IN THE DRAWINGS:

REMARKS

Docket No.: MWB0001.02
Inventor: Jonathan David GADSON et al.
Serial No.: New U.S. Patent Application
Filed: February 24, 2004
Page 1 of 8

FIG. 5

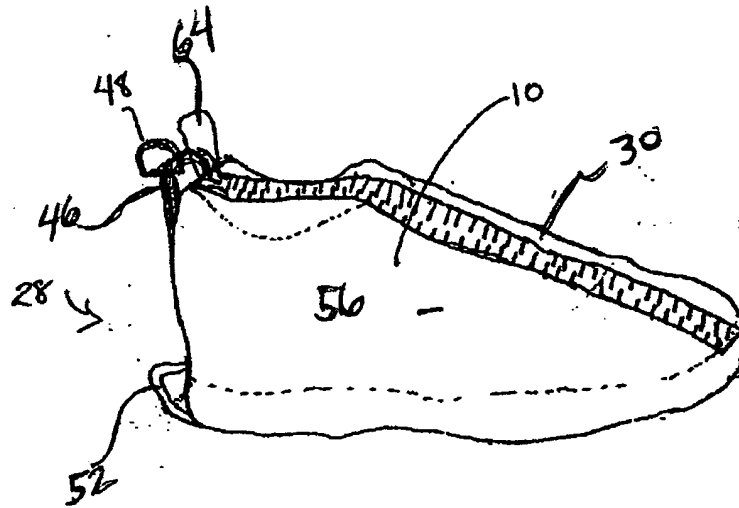
- (1) show the method steps of inserting an article of footwear into the cavity and securing the article by closing the mechanism as claimed in claim 10;
- (2) show the step of sewing the peripheral edge as claimed in claim 12;
- (3) show the step of sewing the mechanism as claimed in claim 13.

Regarding issue (1), the replacement FIG. 5 illustrates the footwear 10 inserted within the cavity 56 of the shoe cover 30. The mechanism 42 is closed to secure the footwear 10 therein.
